RE: PSC Case No. 2006-00065
Oldham County Water District

APPLICATION OF OLDHAM COUNTY WATER)
WATER DISTRICT FOR A CERTIFICATE OF)
PUBLIC CONVENIENCE AND NECESSITY TO) CASE NO. 2006-00065
CONSTRUCT AN ELEVATED WATER TANK)

**RESPONSE TO COMMISSION STAFF'S
INTERROGATORIES AND REQUEST FOR
PRODUCTION OF DOCUMENTS**

EXHIBIT 10-3

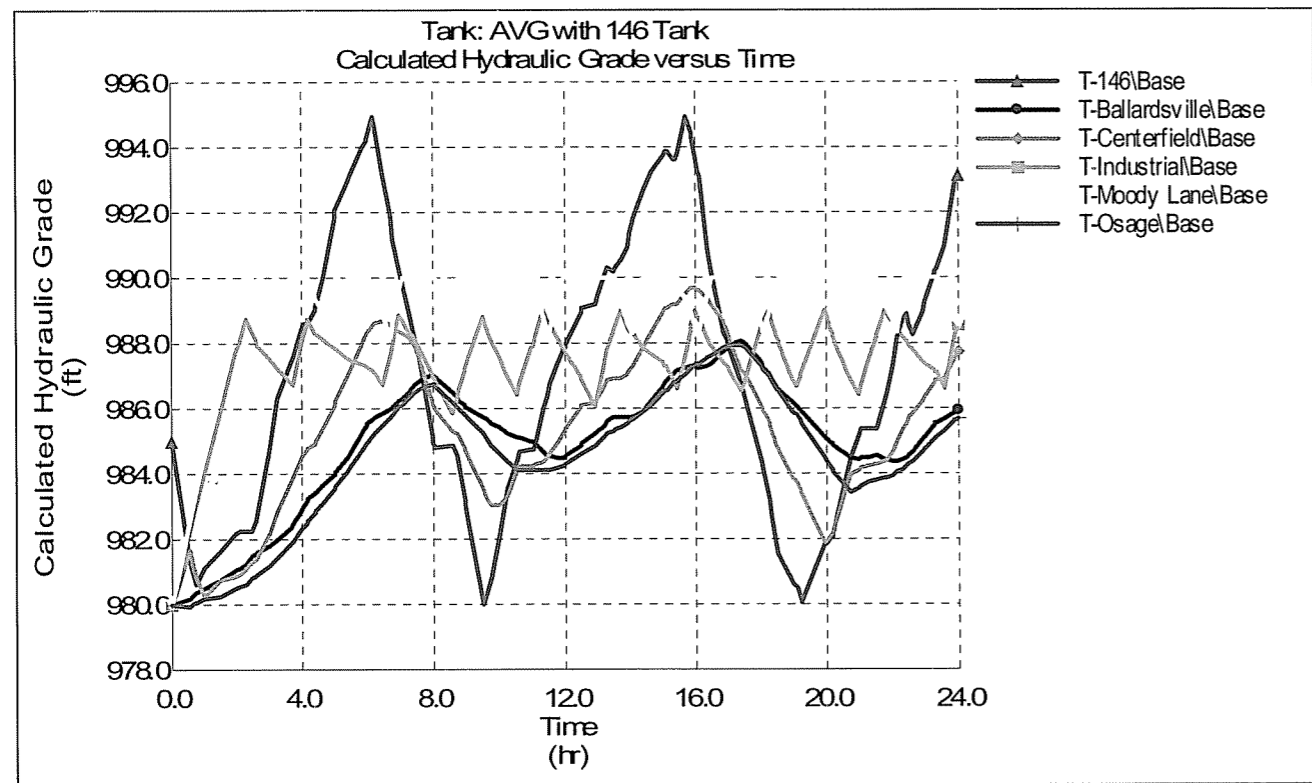
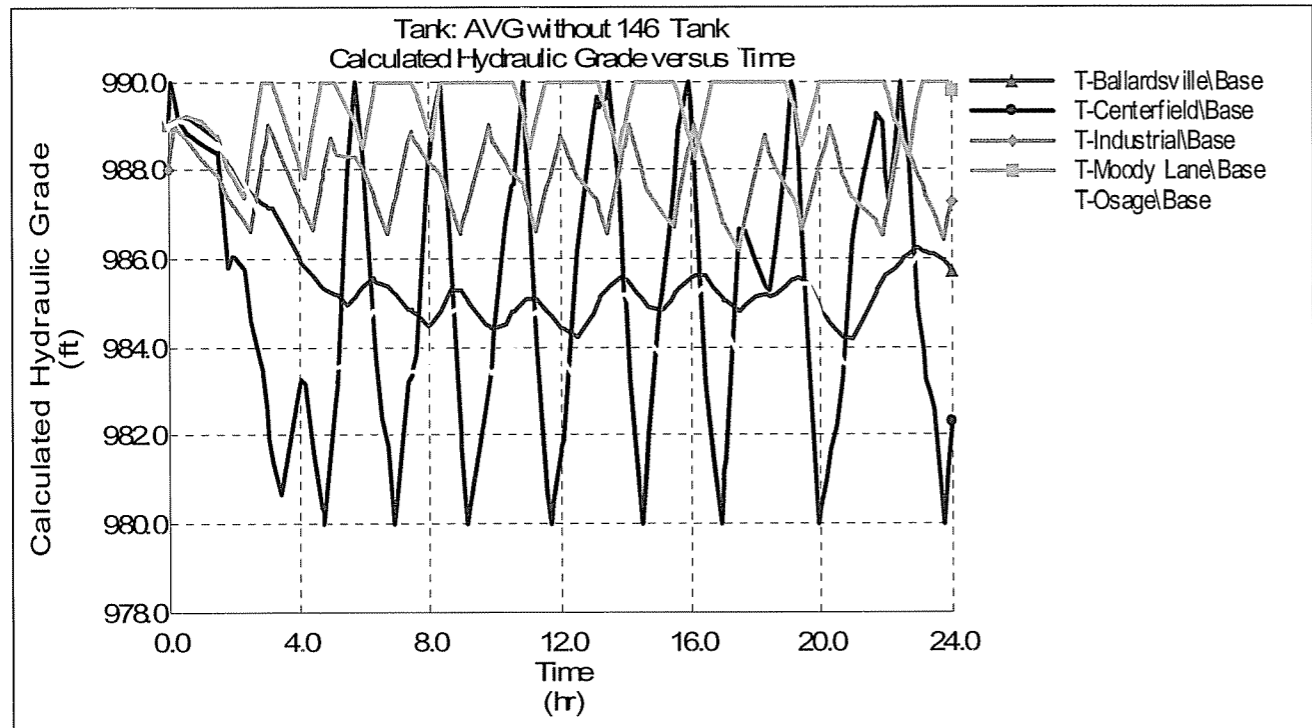
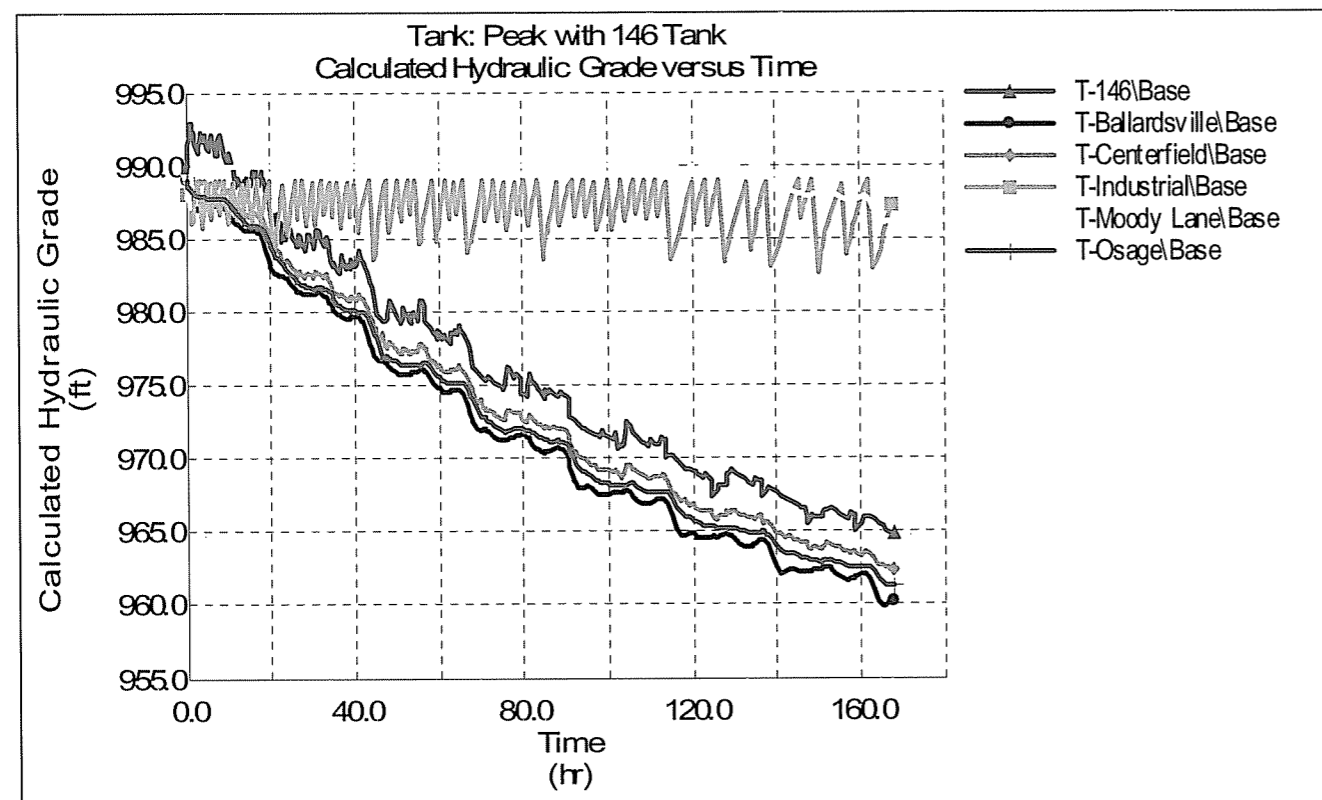
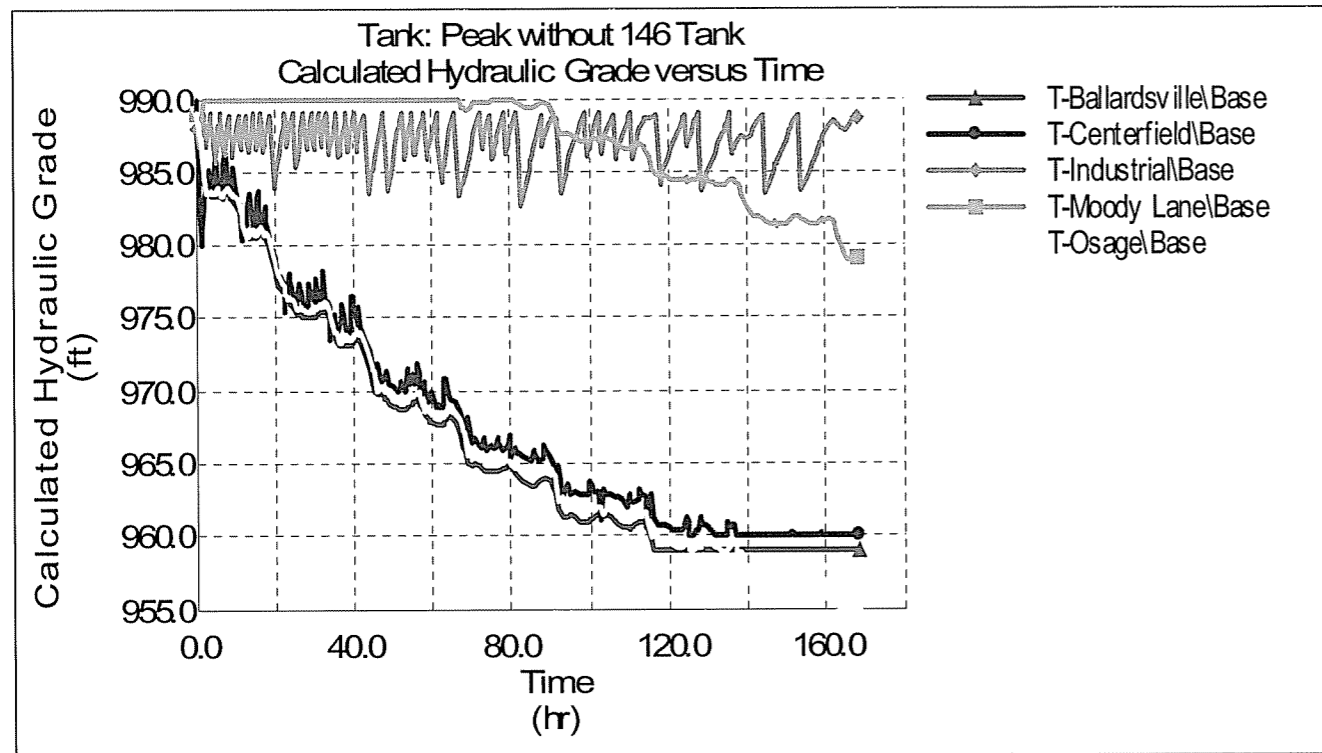
Q10. a. Provide all hydraulic analyses that Oldham District has conducted in developing its plans for the proposed water storage tank.

b. Provide a hydraulic analysis that addresses the facility that Oldham District proposes to construct and its effect on Oldham District's existing distribution system. This hydraulic analysis shall include a simulation of an average daily demand on Oldham District's distribution system and a peak demand that assumes maximum usage by all wholesale, residential and commercial customers.

The first graph shown in **Exhibit 10-3** shows the water levels in the five tanks that are in the 990 pressure zone (Pressure Zone No. 5), during a 7-day period. The daily demand used in this model was equal to the estimated peak daily pumpage during a similar period to the drought experienced during the summer of 2005 (6.2 MGD). The two tanks, which are closest to the water plant, refill daily.

The three tanks, which are furthest from the water plant, do not refill and empty by the end of the 4th day.

The second graph shown in **Exhibit 10-3** shows the water levels in the same five tanks, plus the addition of the proposed 146 Tank. The daily demand is again equal to the peak daily pumpage during the drought summer of 2005 (6.2 MGD). The two tanks, which are closest to the water plant, refill daily. The three tanks, which are furthest from the water plant, do not refill. However, with the addition of the proposed 146 Tank, the tanks do not actually empty and their levels stay higher than without the 146 Tank.
